UNITED STATES DEPARTMENT OF COMMERCE
National Oceanic and Atmospheric Administration
NATIONAL MARINE FISHERIES SERVICE
Southwest Region
501 West Ocean Boulevard, Suite 4200
Long Beach, California 90802-4213

2009/00291:DB

NOAA's National Marine Fisheries Service (NMFS) hereby replies to the U.S. Bureau of Reclamation's (Reclamation) July 14, 2010, letter (SCC-423, ENV-7.00, Cachuma), which inquires whether monitoring the water rights releases (WR 89-18) scheduled to begin on August 2, 2010, is required, and requested formal approval of Reclamation's July 27, 2007, study plan for the subject monitoring.

Memo to file 151422 SWR 2001 PR 231
FROM: Darren Brumback
DATE: October 8, 2009

Figure 1. Comparison of the Santa Ynez River continuous (15-minute) discharge data at USGS gaging stations 11126000 (~0.5 miles downstream of Bradbury Dam) and 11128500 (Alisal Bridge), a distance of approximately 10 river miles, relative to initiating WR 89-18 water releases on July 23, 2007.

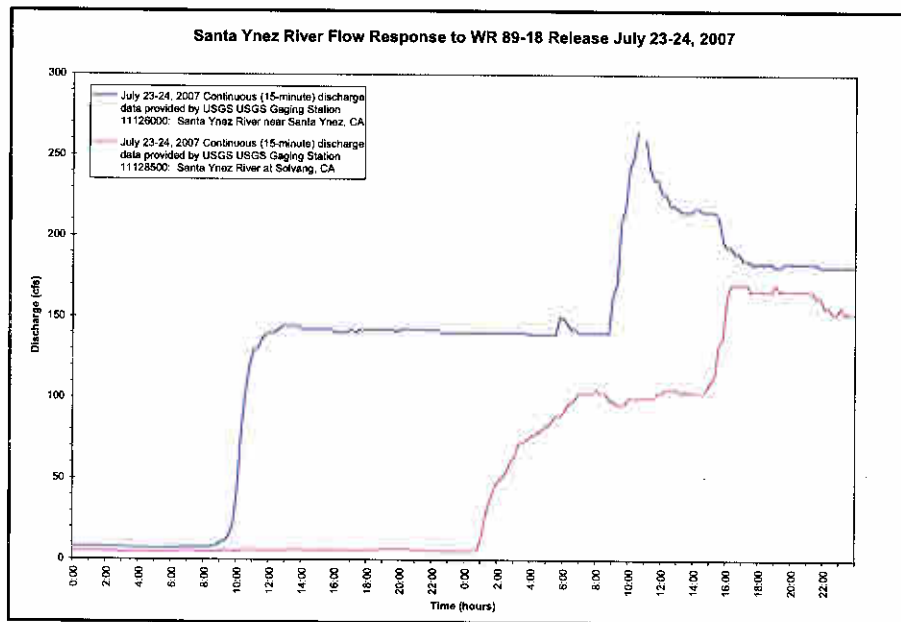
1) Rate of change in flow resulting from initial WR 89-18 releases:

Reclamation's June 13, 2000, Revised Project Description (page 3-18) states the following: *...combined releases (WR 89-18) ... may begin at the rate of 135-150 cfs and are maintained at a steady rate for about 12-15 days before it is gradually decreased to lower flow rates. During the initial 12-15 days, the flow moves at a rate of less than three miles per day* (emphasis added). *... A schedule for ramping flows upward is unnecessary as the travel time of water in the river will attenuate the rate of increase as described above.* However, Figure 1 indicates that Reclamation's estimated rate of change in flows resulting from WR 89-18 is inaccurate. The Santa Ynez River discharge data indicates that a response from the July 23, 2007, WR 89-18 release was realized at the Alisal Bridge within 14 hours, a rate of approximately 17 miles per day. The flow at Alisal Bridge (USGS gaging station 11128500) proceeded to increase from 5.6 cfs to 44 cfs within one hour and reached 100 cfs within six hours. Therefore, the effects of the action may affect endangered steelhead and/or critical habitat in a manner or to an extent not previously considered in the existing biological opinion and incidental take statement.

Figure 2. Comparison of the Santa Ynez River daily average discharge at gaging stations 11126000 and 11128500 (Alisal Bridge), reflecting flow conditions respective of prescribed minimum flows at Alisal Bridge, and water release event occurring prior to WR 89-18 releases on July 23, 2007.

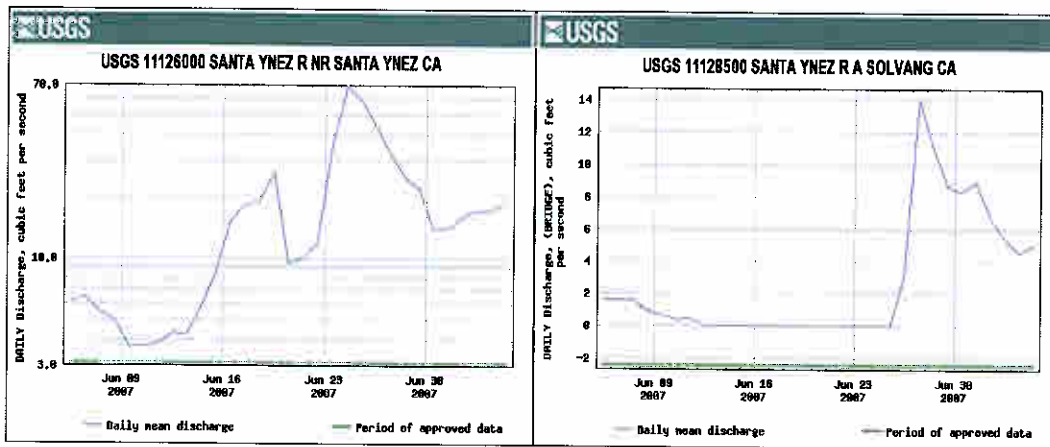
3) Water releases occurring prior to WR 89-18 release:

Page 3 of the Reclamation's January 27, 2009, report presents information regarding flow releases from Bradbury Dam prior to the July 23, 2007, WR 89-18 flow releases. The prior flow release is described as a "refreshing flow" needed to maintain minimum flow conditions (1.5 cfs) at Alisal Bridge (Solvang gage) specified in Reclamation's 2000 biological assessment/project description and subsequently in NMFS' 2000 biological opinion. Figure 2 indicates that minimum flows were not maintained and may have ceased completely between June 7 and June 26, 2007. The October 1, 2007, Incident Report (attached) summarizes these conditions and documents the resulting mortality of three "steelhead/rainbow trout".
